UCRL-AR-113861 Add

**Addendum to the Pit 6 Engineering
Evaluation/Cost Analysis
Lawrence Livermore National
Laboratory Site 300**

November 1996

Figure 8. Potential locations of contingency ground water extraction and treatment system and related monitoring network — revised Alternative 3.

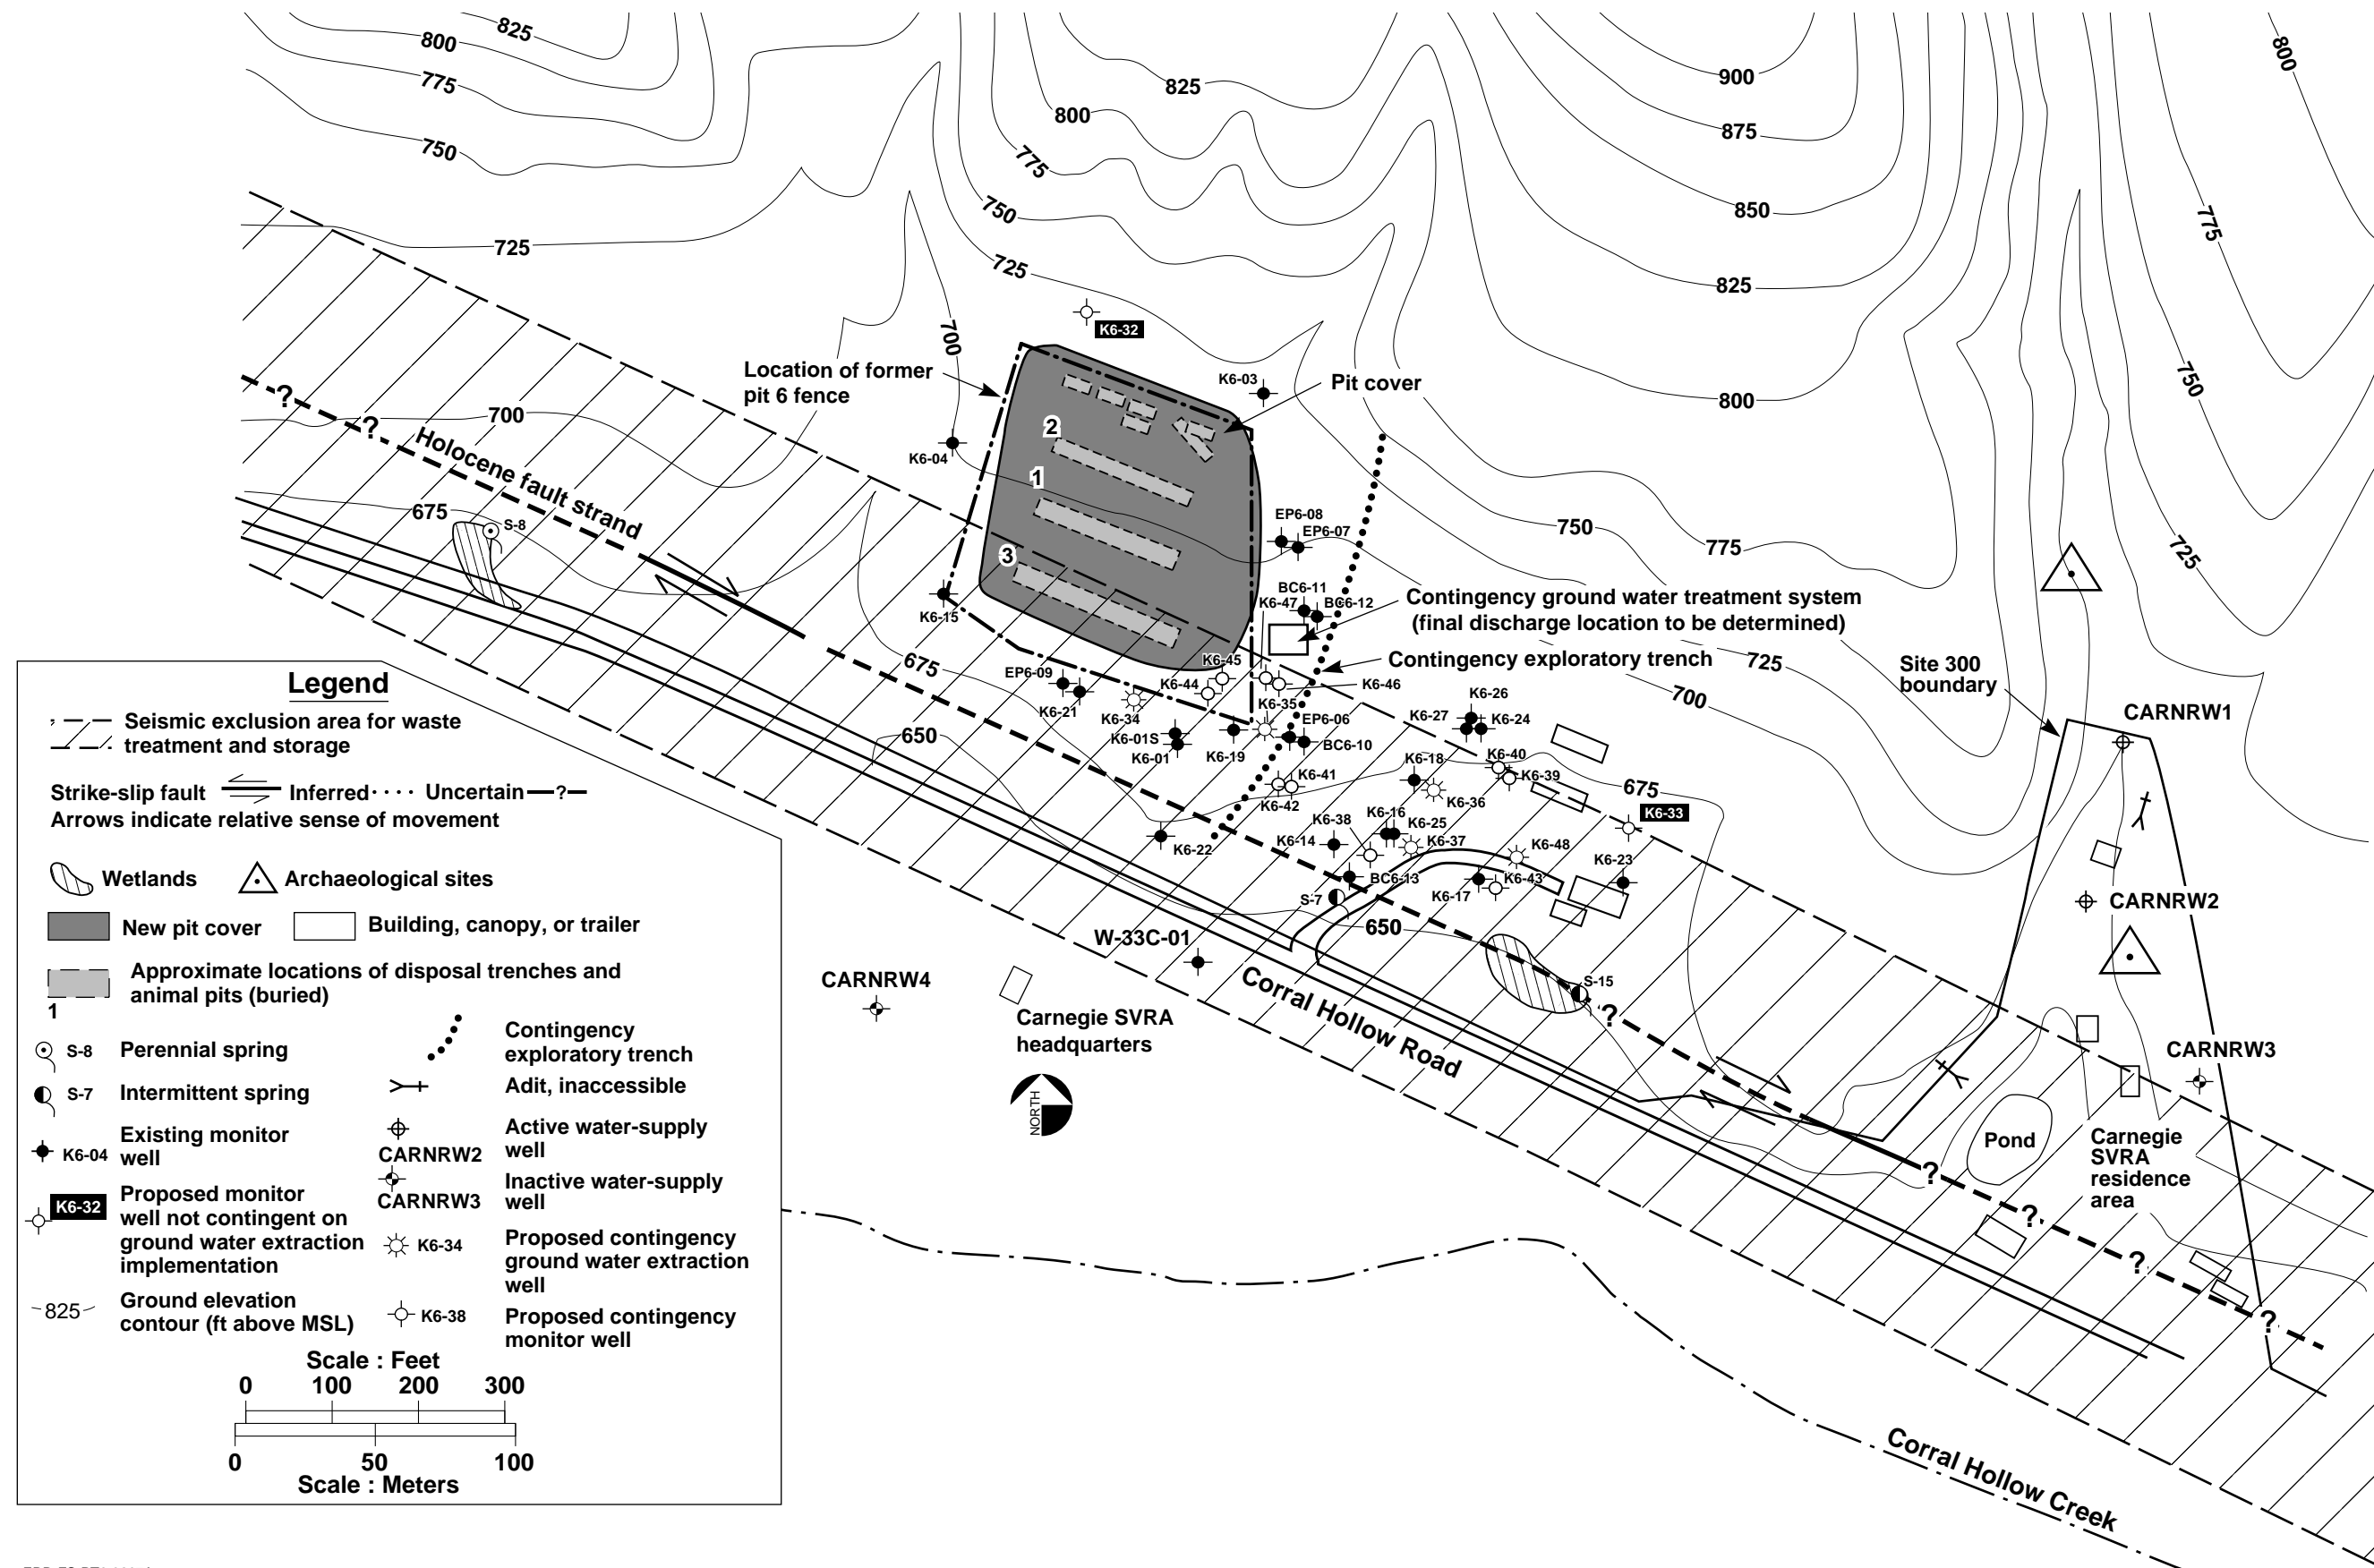
Figure 8 shows the proposed locations for the contingency ground water treatment system and associated extraction and monitor wells. The installation schedule, and the number and location of wells would be re-evaluated at the time of actual design. The seismic exclusion zone and

exploratory trench shown on Figure 8 are related to a location-specific limiting proximity of the ground water treatment system to the Holocene strand of the Carnegie Fault system.
